Re: **Interim Remedial Action Plan Addendum**
8410 – 8430 Amelia Street, Oakland, CA
GeoTracker Global ID T1000000434
ACDEH Site Cleanup Program RO3240

On behalf of Amelia Oakland LLC, Pangea Environmental Services, Inc. (Pangea) prepared this *Addendum* to the *Interim Remedial Action Plan* (IRAP) dated April 3, 2017 for the subject property. As requested during our recent meeting on April 20, 2017, this Addendum presents the planned revised passive subslab ventilation piping locations and additional utility trench plugs (see attached revisions to Figure 8).

Proposed Vapor Mitigation System
Revised May 4, 2017

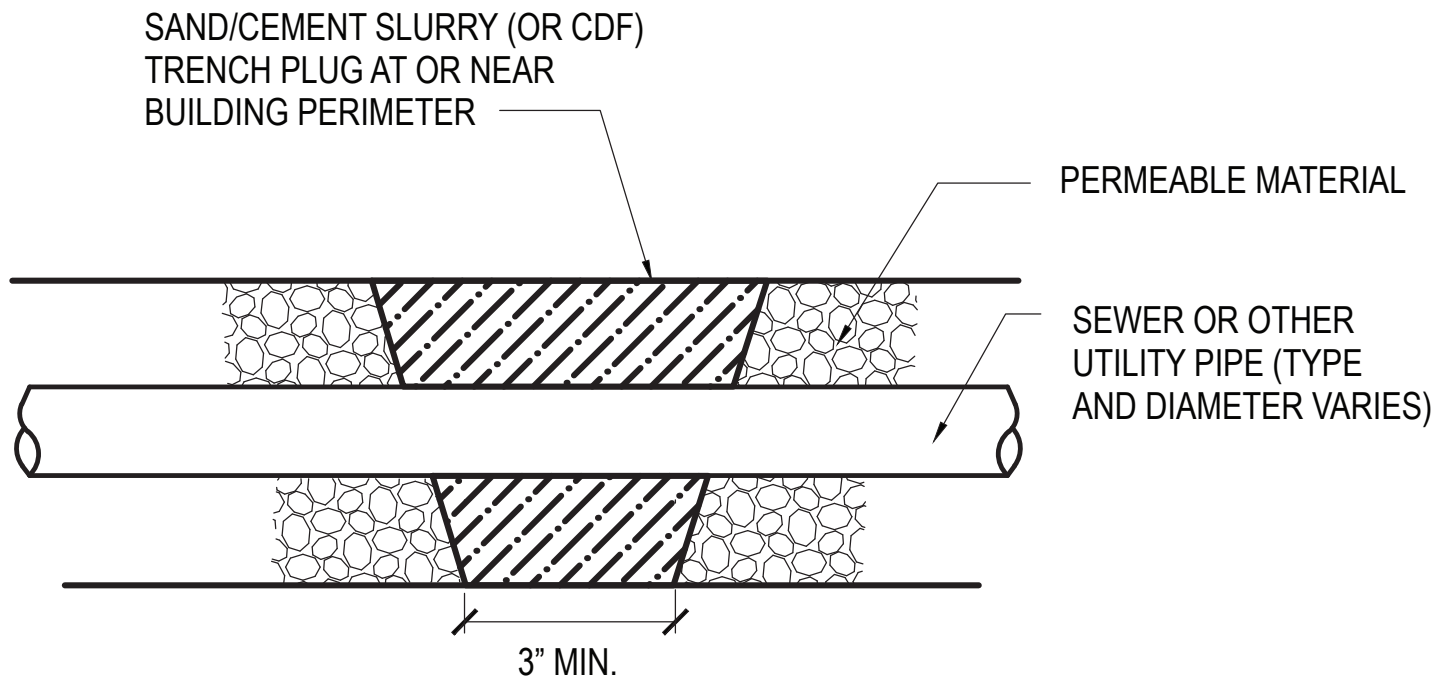
This Addendum proposes slight revision to the passive subslab ventilation system due to revised plans for tenants' sanitary sewer lines and floor drains. Revised Figure 8 shows longer subslab ventilation piping in the central and eastern portion of Building B South (8410A Amelia), and shorter in the western portion of the same building. (The final location of the ventilation piping in the southwestern corner of Building B South may vary for installation with the final sanitary sewer piping). The revised figure shows a manifold location for piping from the proposed subslab gas monitoring probes. The revised figure also shows three additional soil gas barriers within utility trenches (trench plugs) for sewer piping routed to Buildings C and D. New figure 9 shows the trench plug detail.
